10 Mb/s Single Twisted Pair Ethernet 10BASE-T1L PHY Control State Diagram (Comment #584)

10BASE-T1L PHY Control State Diagram

Changes (in red) to:
Figure 146-14 – PHY Control state diagram (part a)

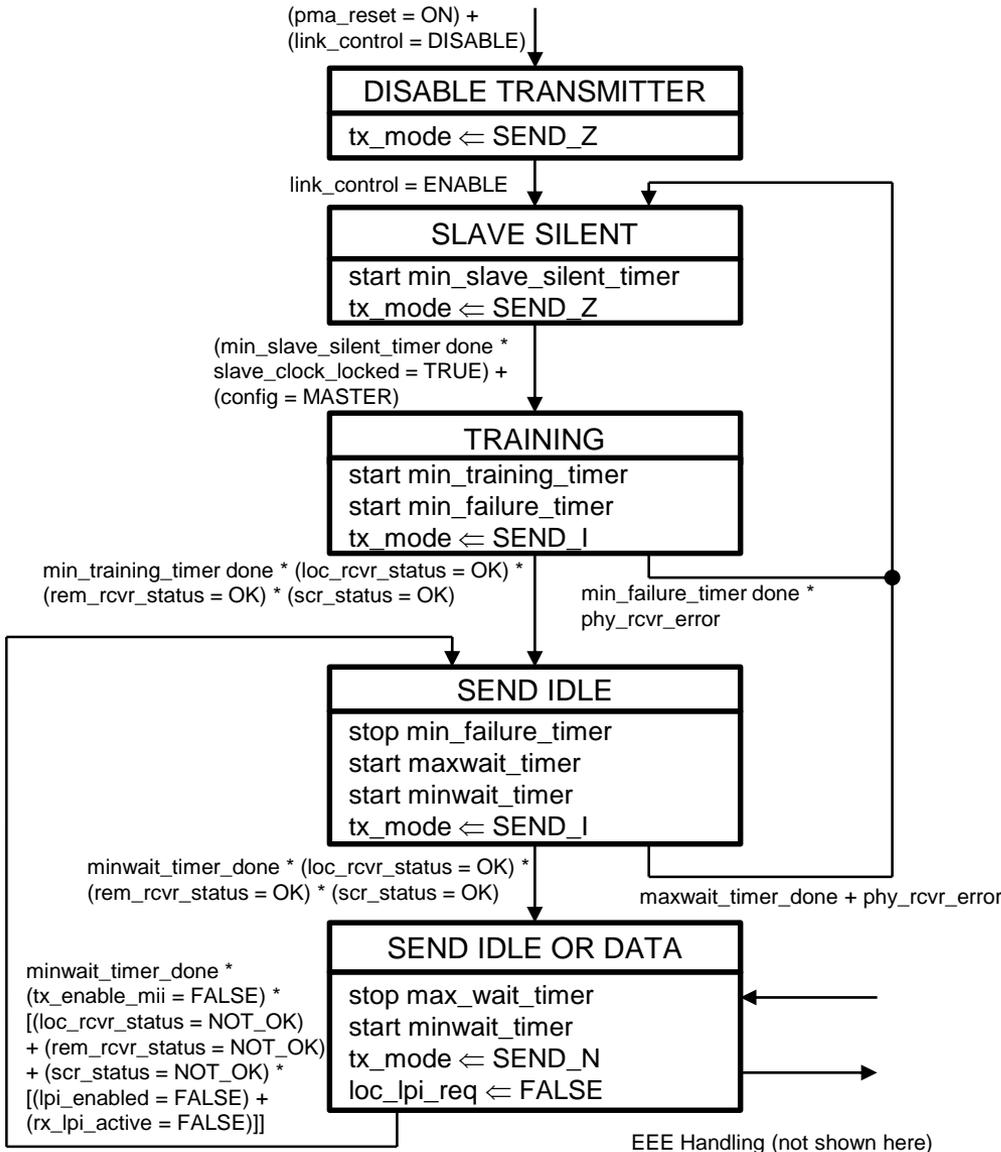
- Depending on the implementation the PHY Control state machine in D2.0, can run into synchronization issues, if FORCE mode is active. See presentation:

- Main reason for these issues is that both, Master and Slave PHY provide a “training_timer”, which limits the maximum time, a PHY may stay in training and if both timers are not synchronized, then it can happen, that for one PHY only a part of the training time remains, so that this PHY cannot finalize the training and therefore has to start training again.
- This condition may, depending on the implementation, persist for a longer time.
- To solve this issue, some changes in the PHY Control state machine are suggested.

This state machine can now be simplified by combining the Master and Slave training states (see next page).

Implementing these changes, the PHY Control state diagram can be simplified by using the same „TRAINING“ state for Master and Slave PHY.

Timers (need to be added to the timer section):

min_slave_silent_timer:

Minimum time (10 ms ± 1 ms) the slave PHY stays in silent mode.

min_training_timer:

Minimum time (10 ms ± 1 ms) the PHY stays in training mode.

min_failure_timer:

Minimum time (50 ms ± 1 ms) the slave PHY stays in training mode before going back to „SLAVE SILENT“ state, if the slave PHYs clock is not locked anymore or another unrecoverable error is detected.

- `slave_clock_locked` (needs to be added to the variables section):
This variable is set TRUE, if the clock recovery circuit on the slave PHY detects a stable clock, locked on the Master PHY clock. Implementations may benefit from checking `scr_status` for deciding, if the slave clock is locked.
Values: TRUE or FALSE

- `phy_rcvr_error` (needs to be added to the variables section):
This variable is set TRUE, if the receiver of the PHY detects an unrecoverable error, which requires a restart of the training (triggering of `phy_rcvr_error` is implementation specific).
Values: TRUE or FALSE
